STATE HIGHWAY 105 / JACKSON CREEK PARKWAY - PHASE 2

CONSTRUCTION PLANS

Comments provided by DPW Development Services

Comments provided by DPW Capital Projects

STORM SEWER PLAN & PROFILE

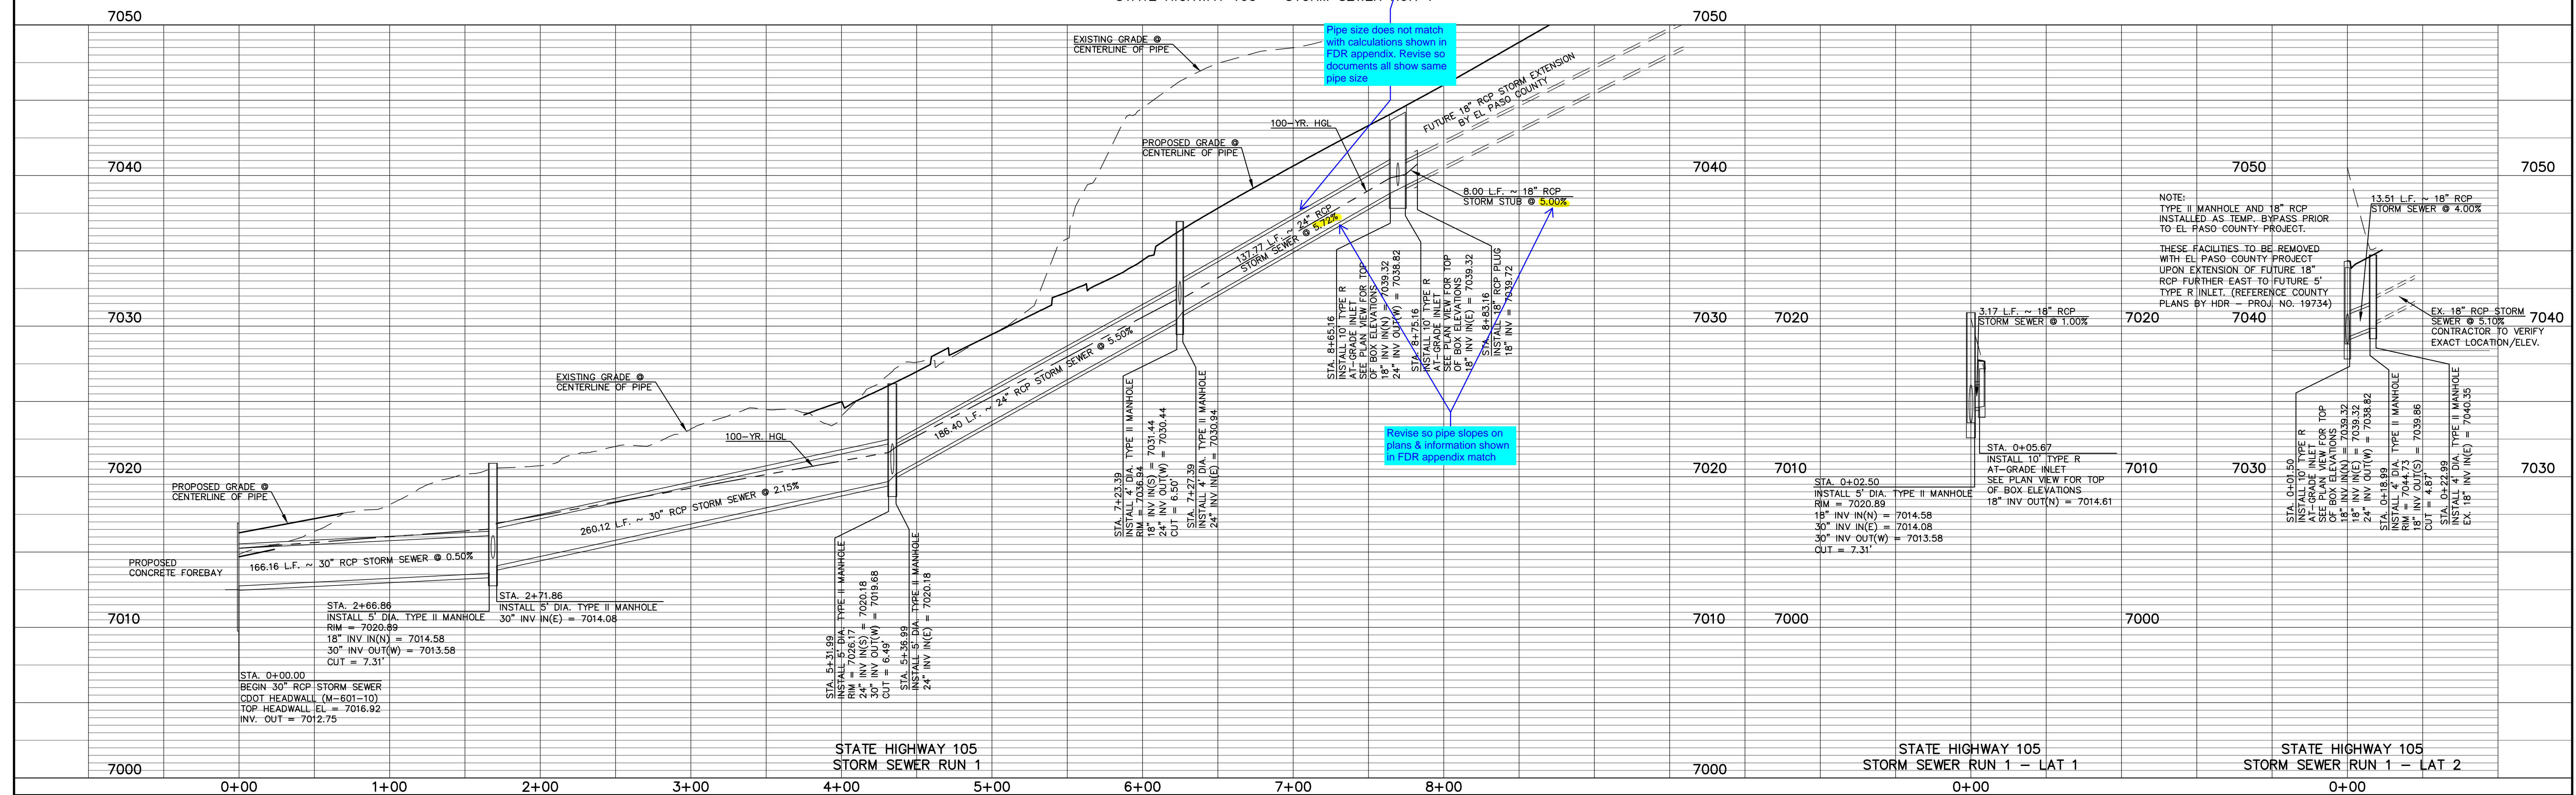
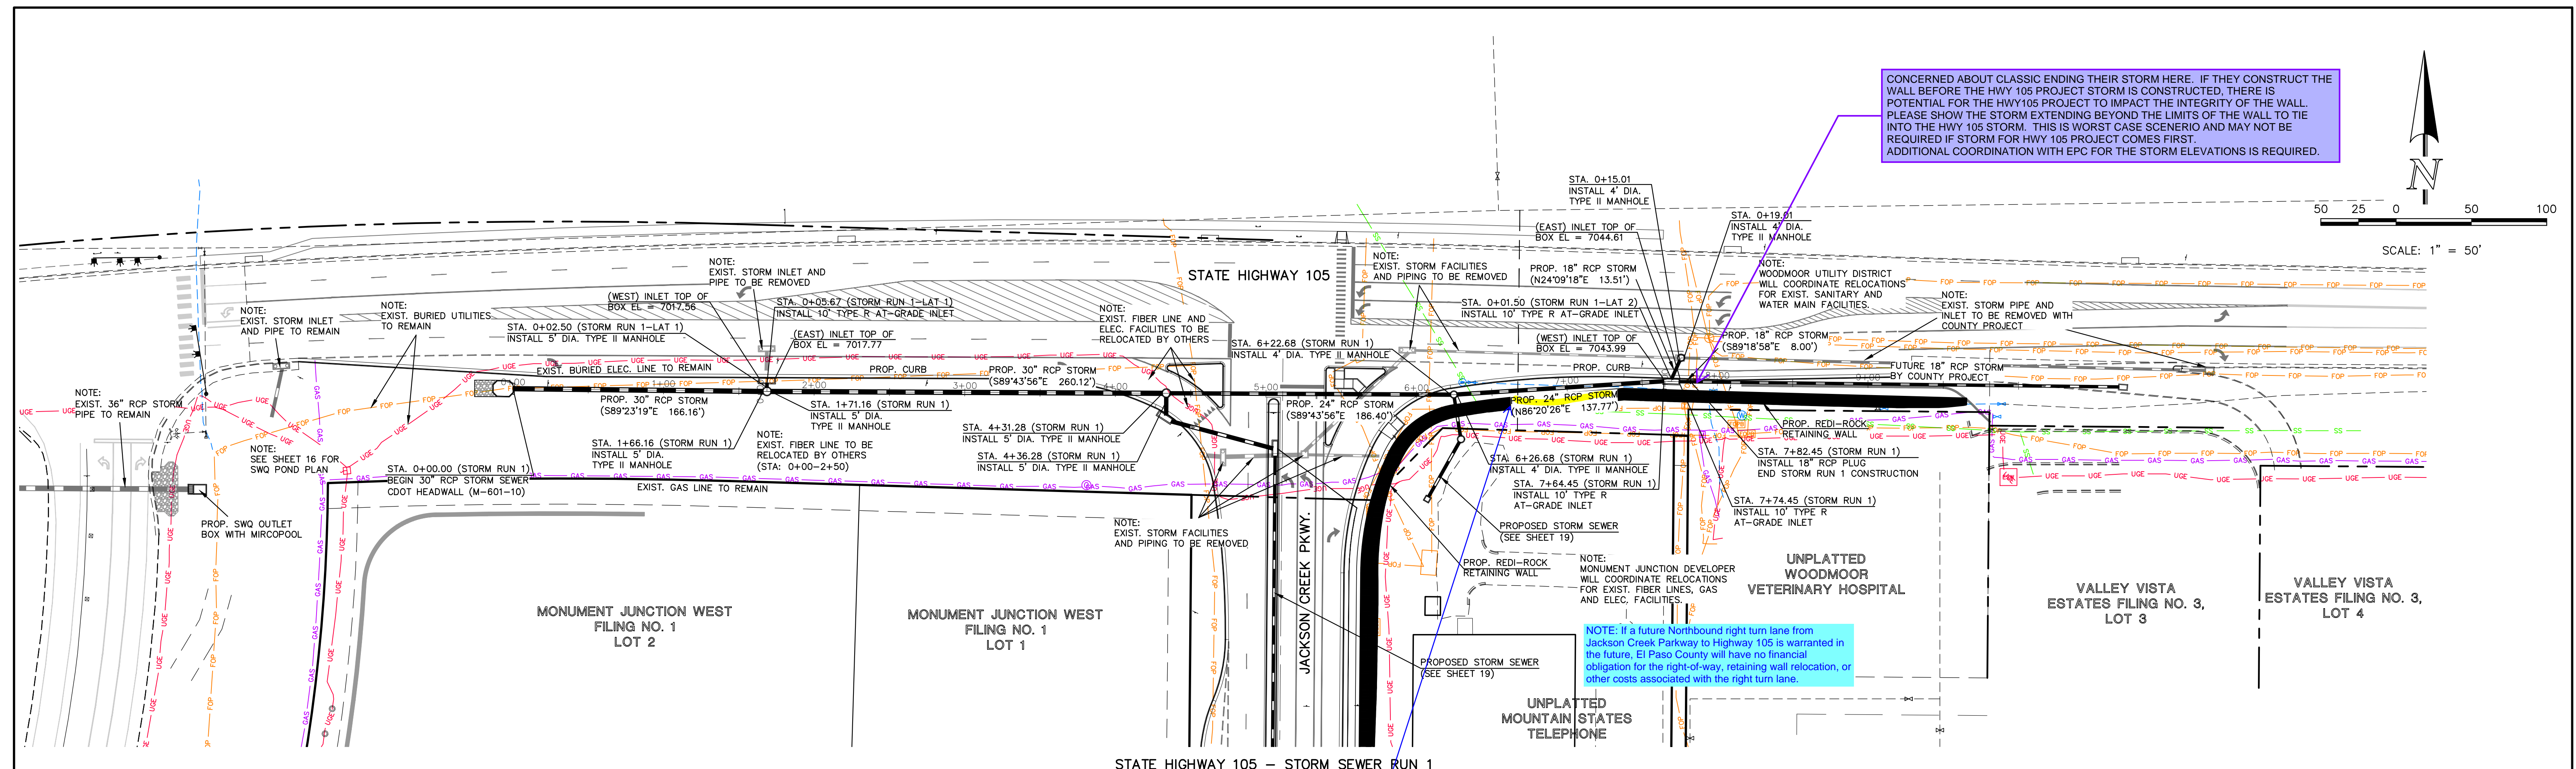
CONCERNED ABOUT CLASSIC ENDING THEIR STORM HERE. IF THEY CONSTRUCT THE WALL BEFORE THE HWY 105 PROJECT STORM IS CONSTRUCTED, THERE IS POTENTIAL FOR THE HWY105 PROJECT TO IMPACT THE INTEGRITY OF THE WALL. PLEASE SHOW THE STORM EXTENDING BEYOND THE LIMITS OF THE WALL TO TIE INTO THE HWY 105 STORM. THIS IS WORST CASE SCENARIO AND MAY NOT BE REQUIRED IF STORM FOR HWY 105 PROJECT COMES FIRST. ADDITIONAL COORDINATION WITH EPC FOR THE STORM ELEVATIONS IS REQUIRED.

Pipe size does not match with calculations shown in FDR appendix. Revise so documents all show same pipe size

Revise so pipe slopes on plans & information shown in FDR appendix match
